Tennessee Valley Authority, Post Office Box 2000, Spring City, Tennessee 37381-2000

WATTS BAR NUCLEAR PLANT (WBN) UNIT 1 - RESPONSES TO REQUEST FOR  
ADDITIONAL INFORMATION (RAI) REGARDING TRITIUM PRODUCTION -  
INTERFACE ITEM NUMBER 3 - COMPLIANCE WITH DNB CRITERION -  
CLARIFICATION TO PREVIOUS RAI RESPONSE DATED SEPTEMBER 21, 2001  
TAC NO. MB1884

**ENCLOSURE**  
**TENNESSEE VALLEY AUTHORITY**  
**WATTS NUCLEAR PLANT (WBN)**  
**UNIT 1**  
**DOCKET NO. 390**  
**RESPONSE TO NRC'S REQUEST FOR ADDITIONAL INFORMATION**

Figure 3.1  
Results of Analysis of Condition I Power Shapes

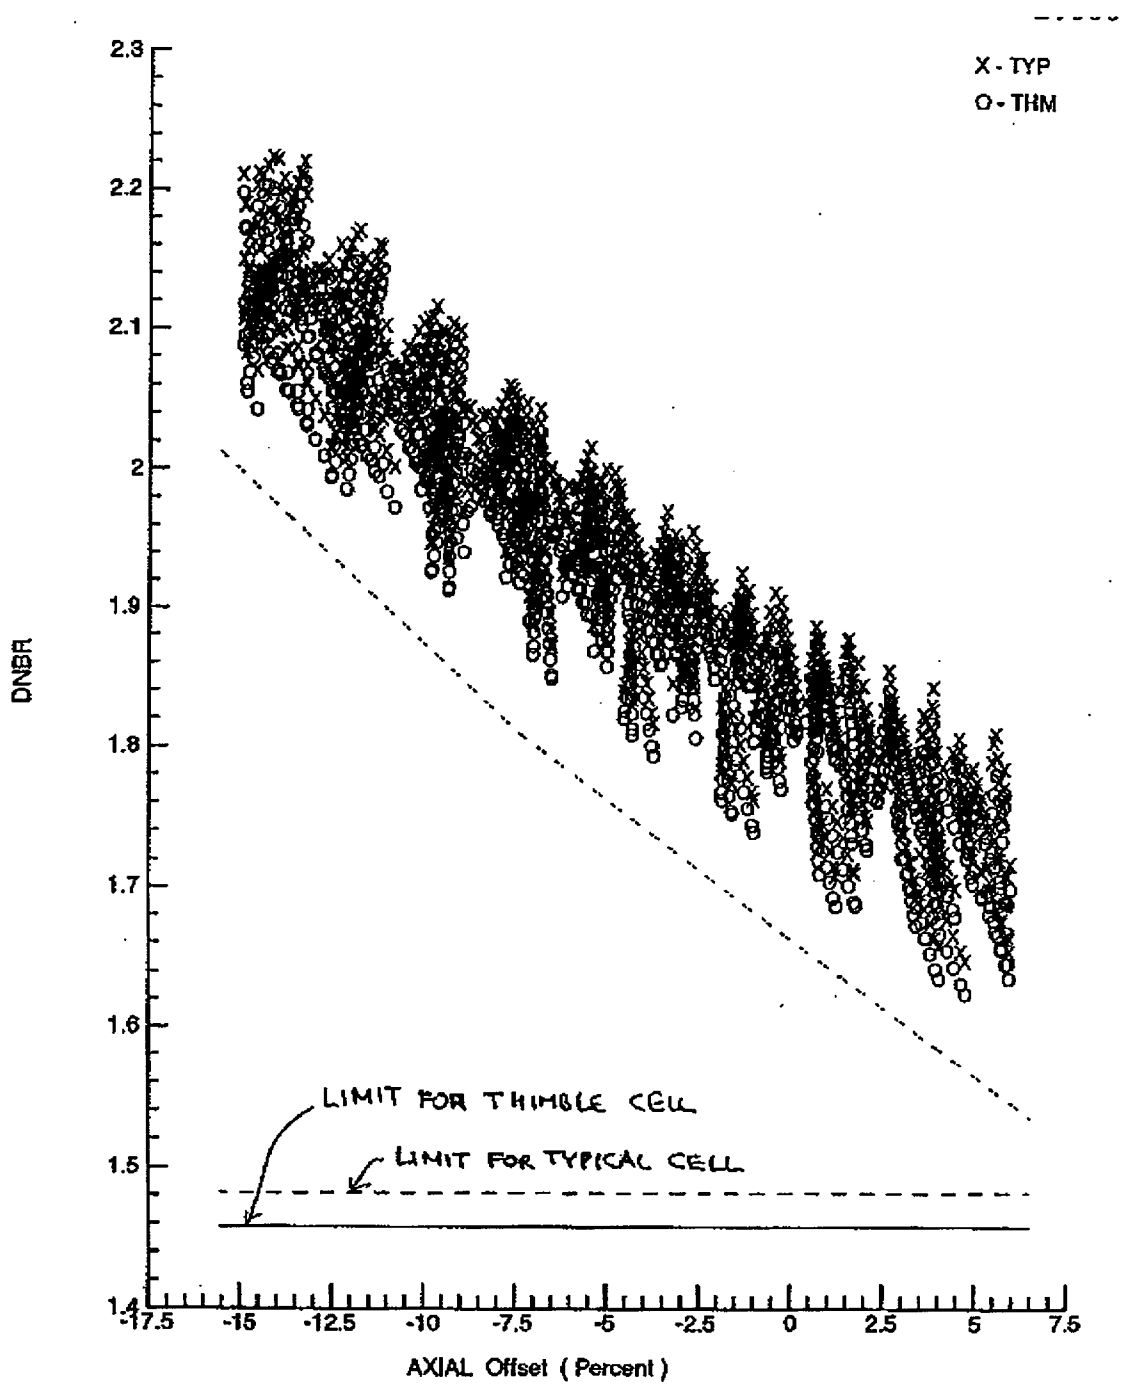
Figure 3.1 shows the results of the analysis of the Condition I axial power shapes for an equilibrium core of TPBARs. The figure plots DNBR versus Axial Offset, where Axial Offset is defined as the power generated in the top half of the core minus the power generated in the bottom half of the core divided by the total power generated (times 100 to give the standard unit of percent). Each circle or x corresponds to a power shape for a thimble or typical cell, respectively. The dotted line which bounds the data points is taken from the reference power shape analysis for a non-tritium core. This line is used to verify future cycle specific power shapes. The horizontal limit lines show on the figure for the thimble and typical cell correspond to a DNB limiting axial power shape used to analyze such transients as Loss of Flow.

Figure 3.2A  
 Results of Analysis of Condition II Power Shapes  
 Typical Cell

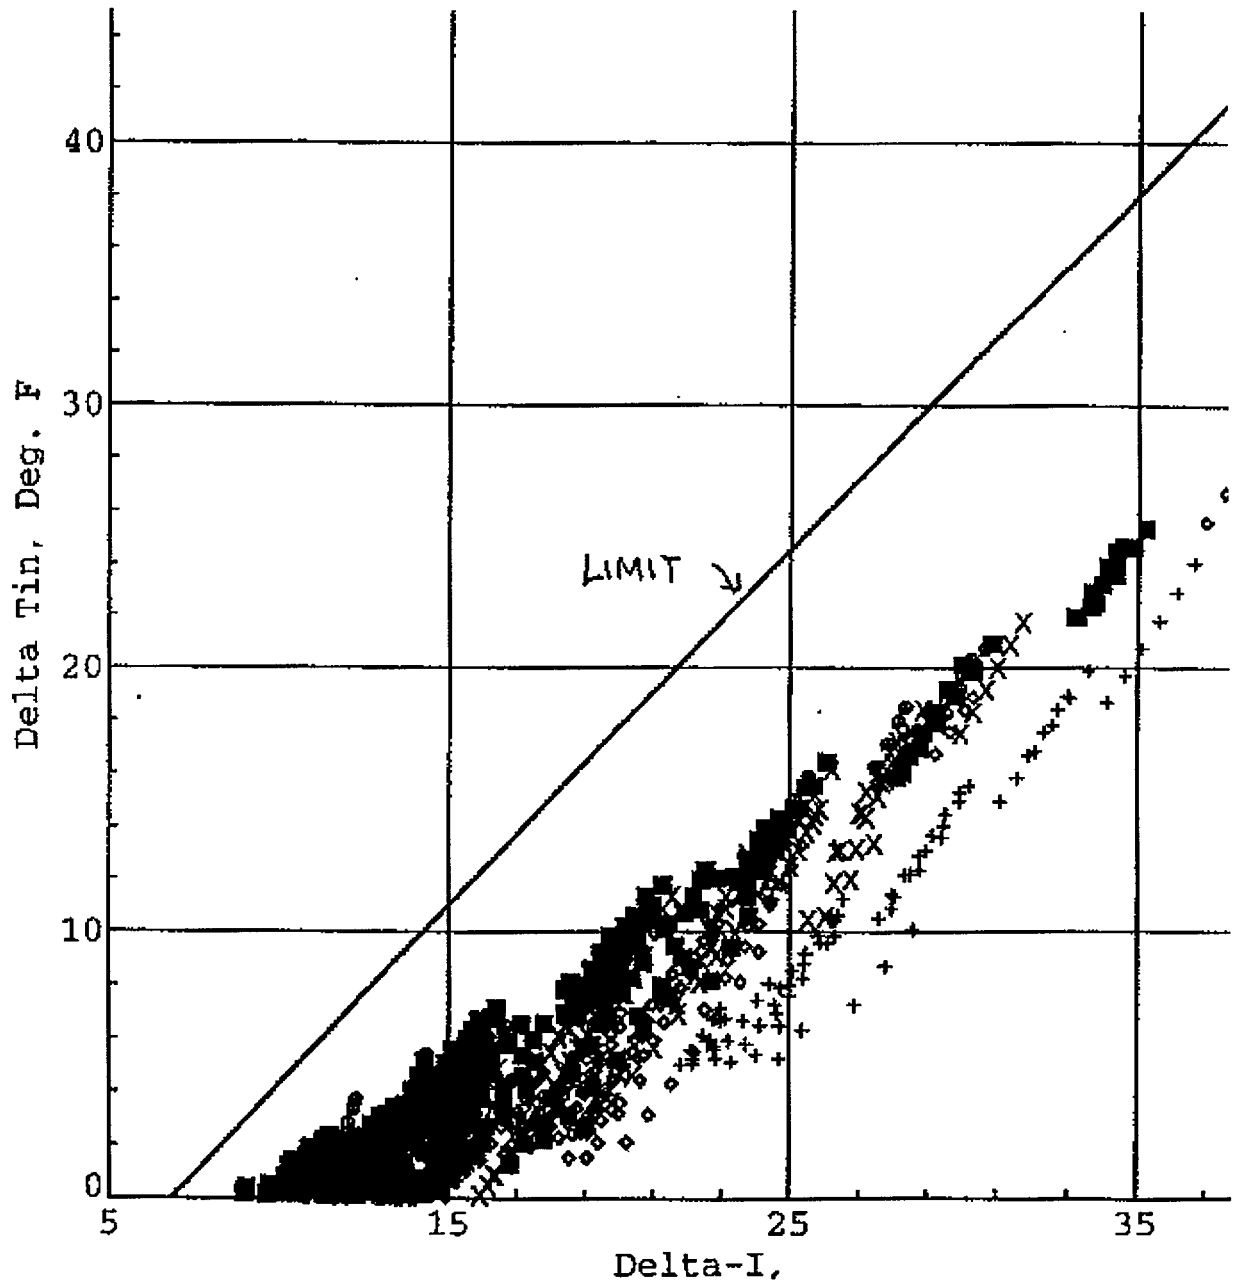
Figures 3.2A/B show the results of the analysis of the Condition II axial power shapes for an equilibrium core of TPBARs for typical and thimble cells, respectively. The figures plot  $\Delta T_{in}$  versus  $\Delta I$ , where  $\Delta I$  is defined as percent of core rated power generated in the top half of the core minus percent of core rated power generated in the bottom half of the core. Each point corresponds to a power shape.

These figures show that the limit lines bound the accident power shapes associated with the tritium cores. The limit lines were established for non-tritium cores and are applicable to the tritium cores. These lines were used as input to establish the  $f(\Delta I)$  function setpoints in the Overttemperature  $\Delta T$  equation.

On pages E-7 and E-8, revise the titles for Figures 3.2A and 3.2B as per attached pages (changes denoted by revision bars):
